MICHAEL LEWIS A R C H I T E C T S P C 145 Palisade St • Suite 307 • Dobbs Ferry, NY 10522 • 914.231.7700 • info@mlarchitect.com

Re: Proposed work at 99 Main Street - Application # A2024-0047

Below are our responses in RED, to the AHRB-PB review by Nelson Pope Voorhis dated March 29, 2024. We are submitting revised drawings as well for our AHRB-PB re-file and our 5.2.24 meeting.

DATE: March 29, 2024 RE: 99 Main Street

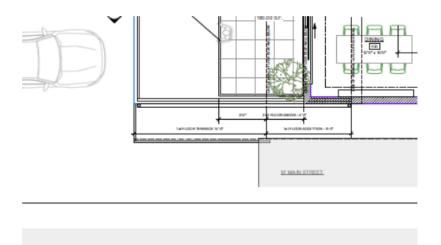
- 5. **Fence and gate.** It appears the proposed fence and gate at the rear of the alley may be located on the adjoining property at 97 Main Street. Please clarify the location of the fence/gate in reference to the property line. See below. MLA We part of the existing gate is on the 97 Main lot. Our new fence will be appx 6"+ to the North, all on the 99 Main St lot.
